Town of Medway
DESIGN REVIEW COMMITTEE
 155 Village Street, Medway MA 02053
 (508) 533-3291

DRC Meeting Minutes: August 03, 2020
 Remote Meeting

Site and Landscaping Plan Review – Harmony Village , 218-220 Main Street

LANDSCAPE PLAN

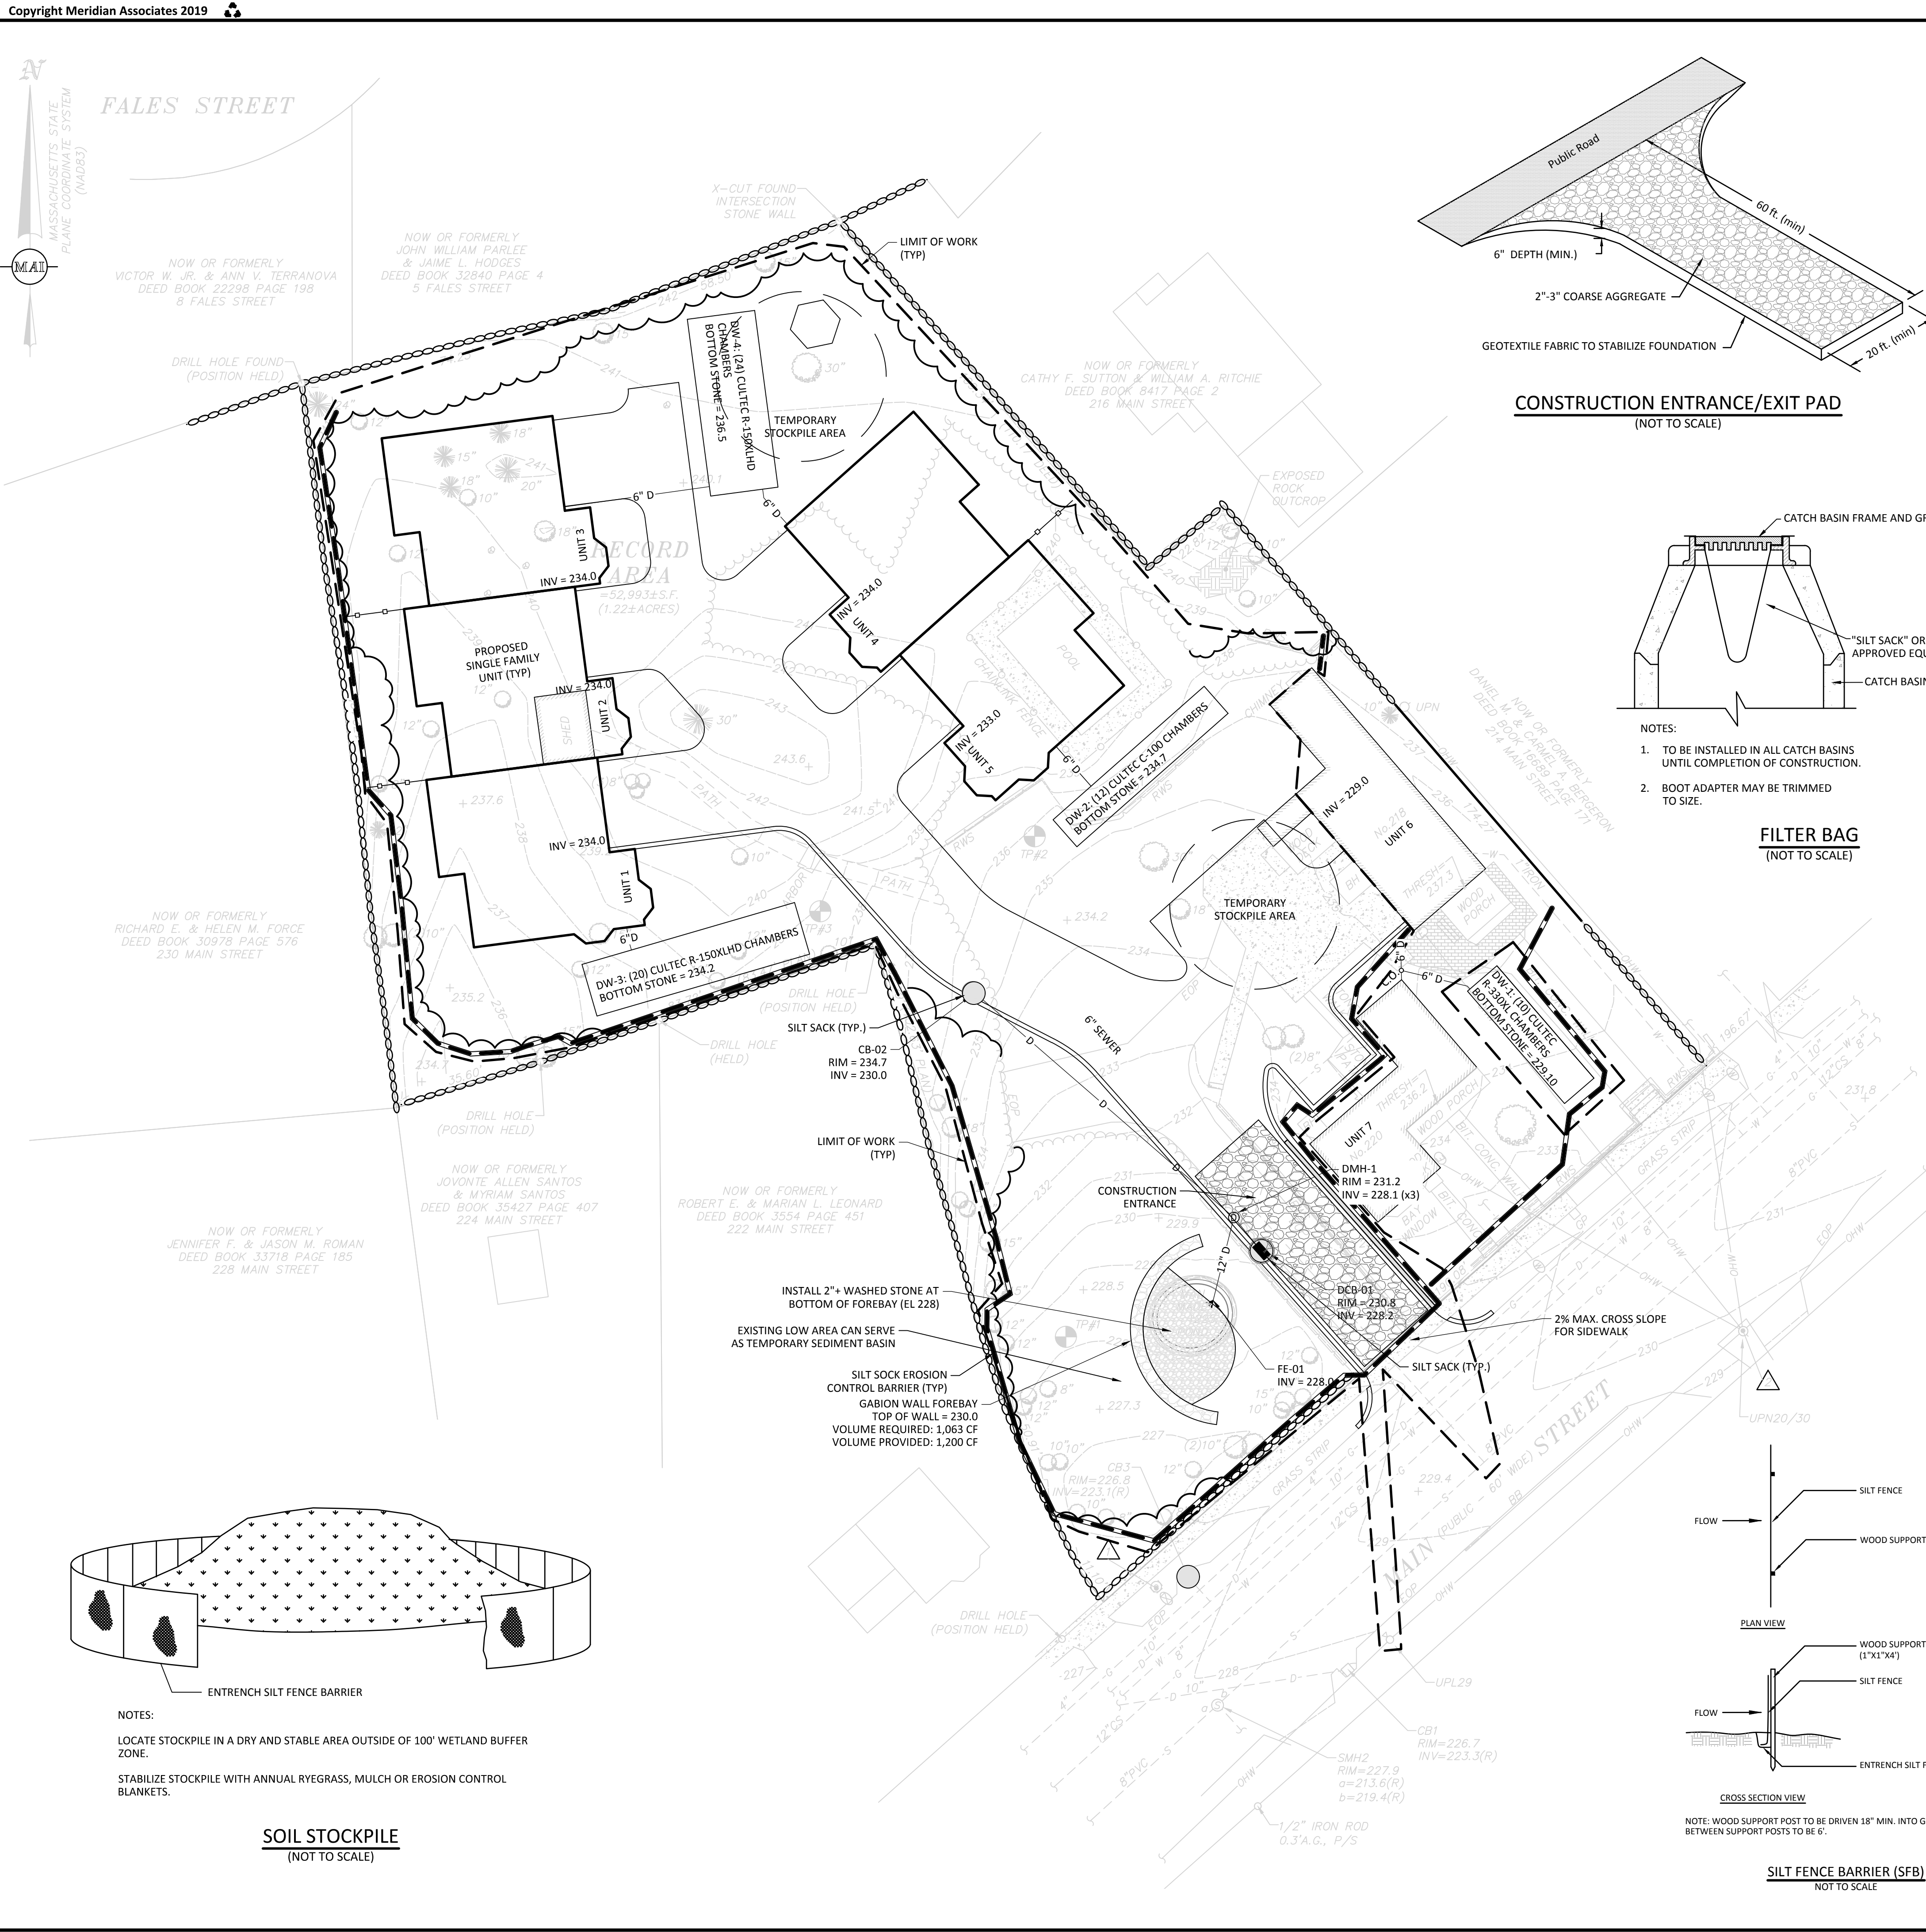
Mr. Gay asked if the Fire Department was invited to investigate turning around the equipment in the existing driveway and the response was yes. There was a question on the proposed buffer plan between the property to the east/northeast and the duplex. A white vinyl privacy fence (10' high) is proposed to separate the duplex and triplex. It is called out in the plans between the units. Area to the back of the triplex is wooded. All proposed trees will be on the other side of the stone wall.

Discussion ensued on the proposed fence and/or the line of trees/vegetation that separates the private property and the proposed project. Designer agreed to look into fencing with breaks in between where the stone wall will be visible. Plantings will be installed in those locations. Green space in the front will be cleaned up.

The grade around the large tree in the back will be cut by about 18" and will be mounded. The tree will be retained. Trees along Main Street will be looked into and all healthy trees will be retained.

For the landscaping plan, Ms. Affleck-Childs will provide the plants list to Ms. Trainer. On architectural side of things, Mr. Pacifico talked about the design changes they have made. The bay windows that were commented on last time have been removed from the design. Slightly bigger corner boards were suggested.

EXTERIOR ELEVATIONS

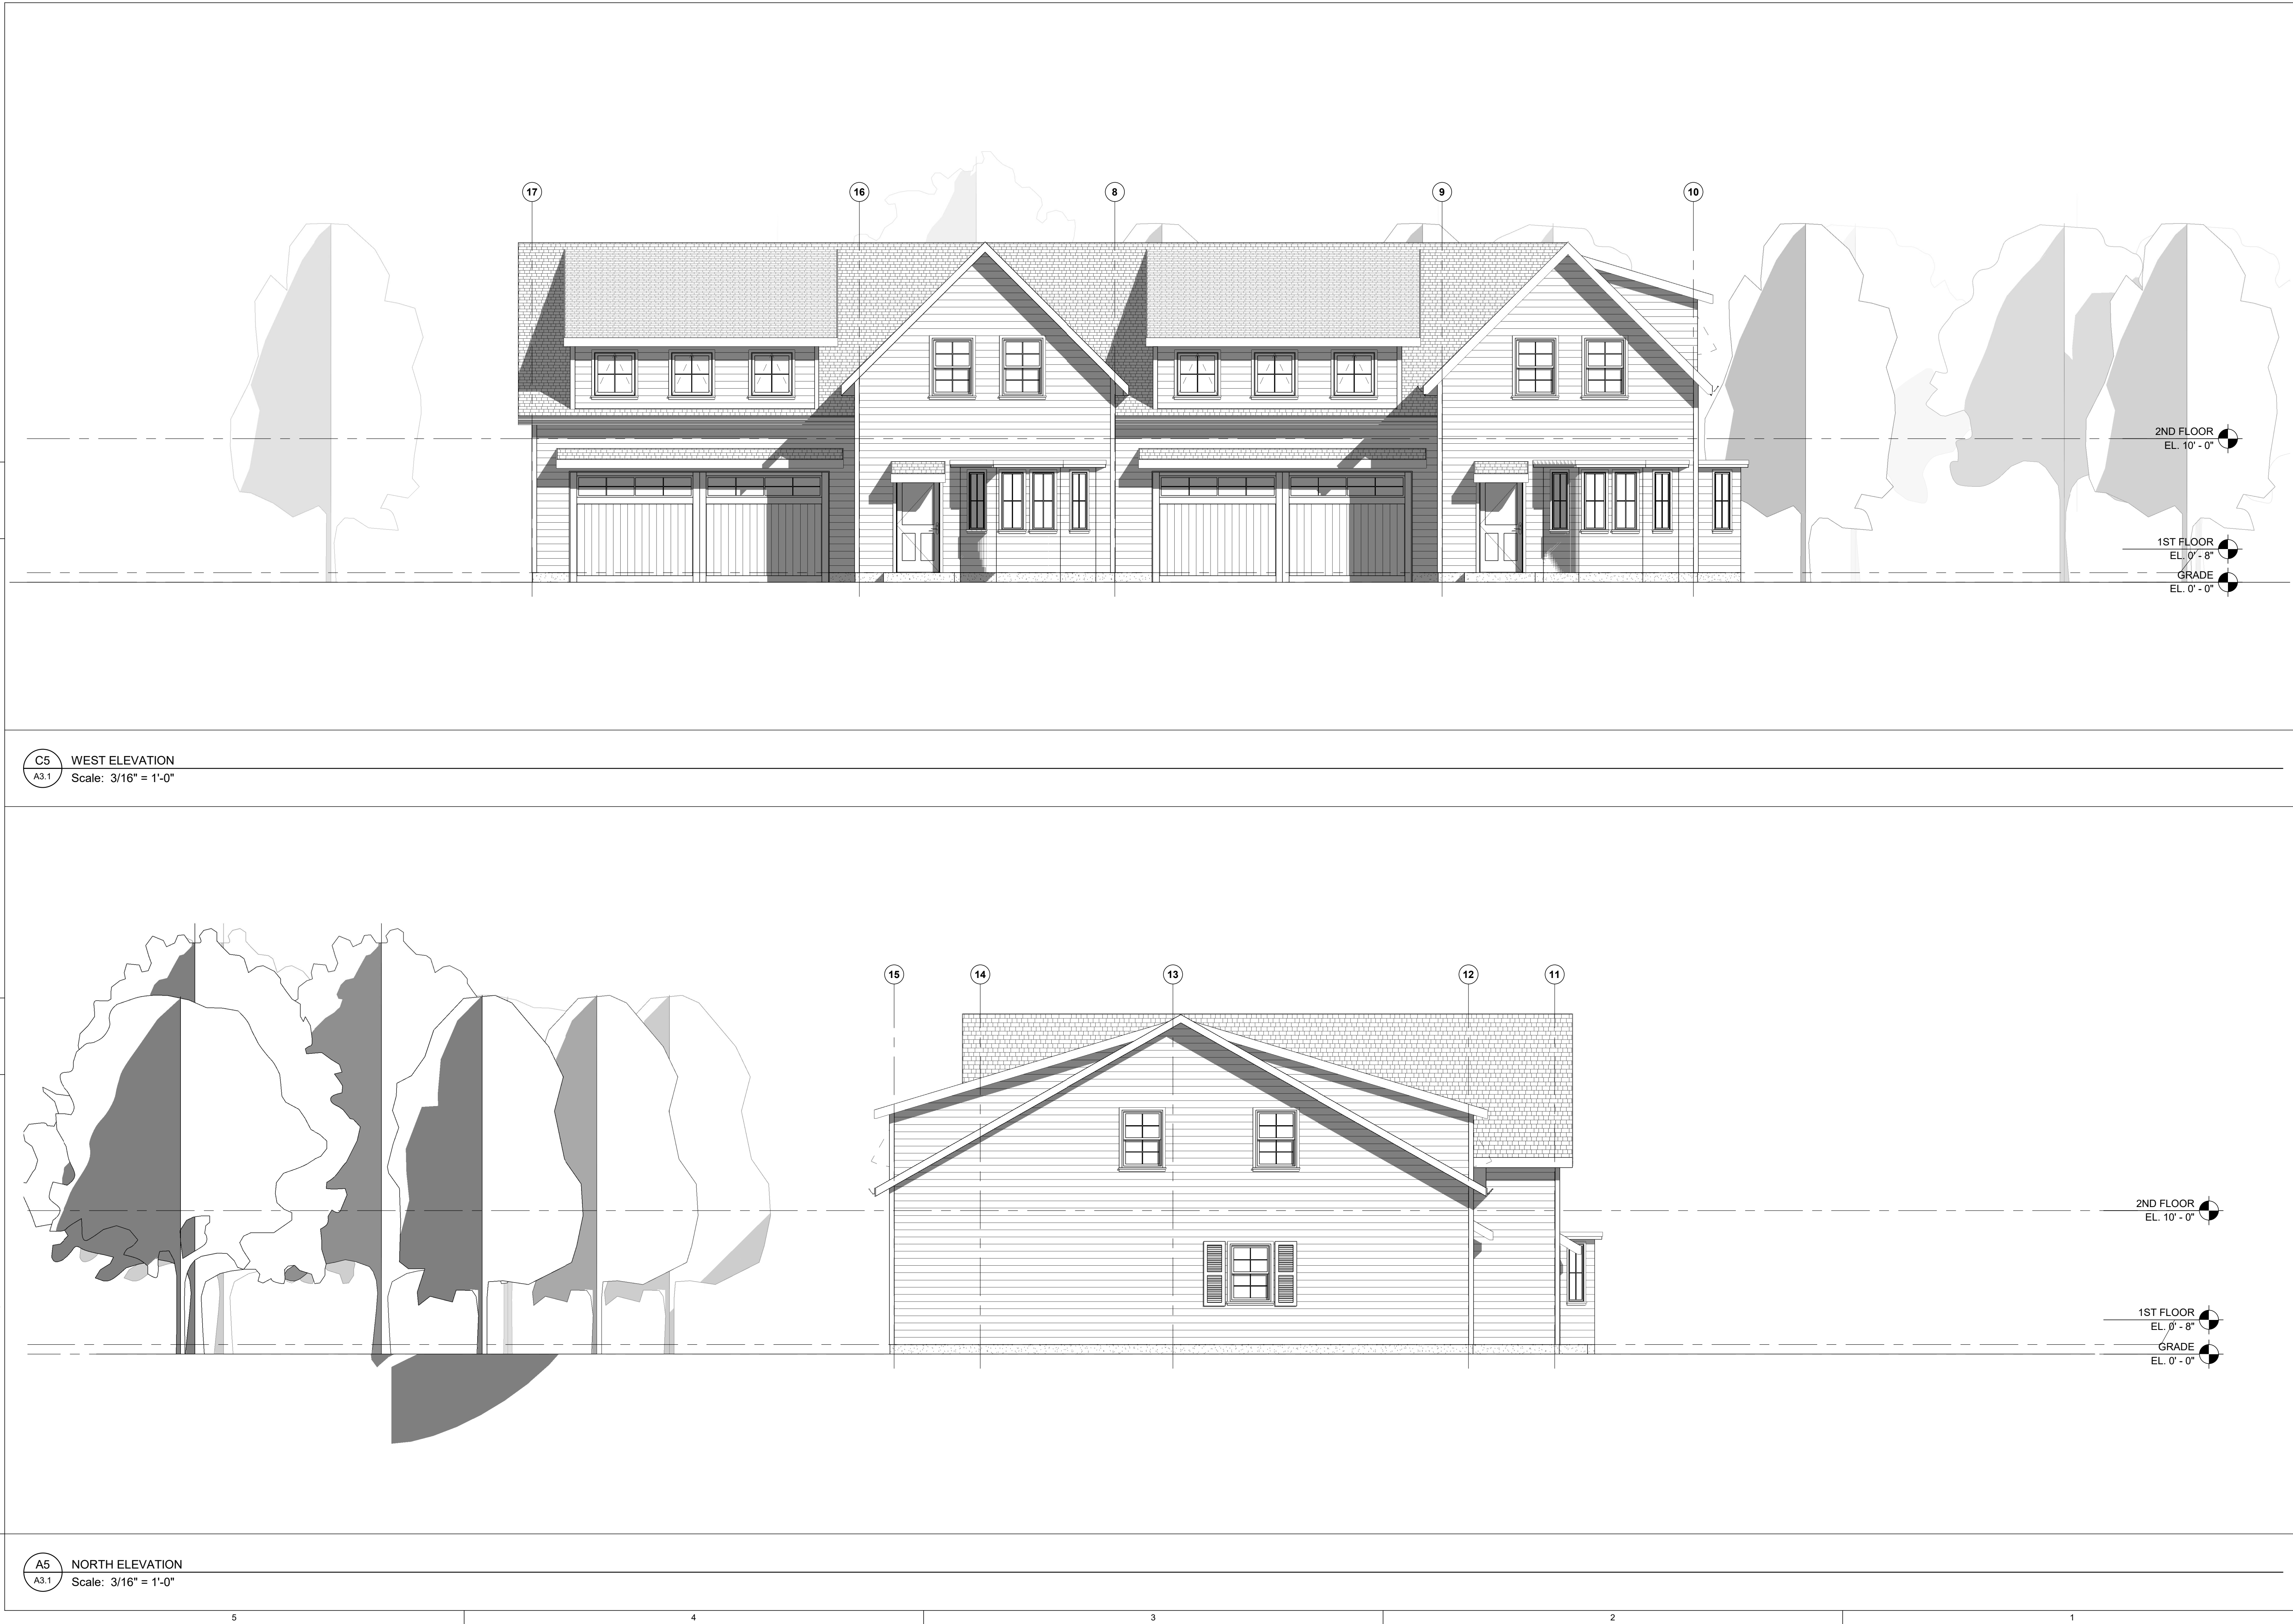
The two existing houses are white in color and the roofing, siding, and windows will be replaced. Everything else will be retained. Beige and light grey colors are proposed for the new units. Garage doors will be white and front door colors have not been decided yet. Mr. Buckley suggested submitting all the color details to the committee for further review.
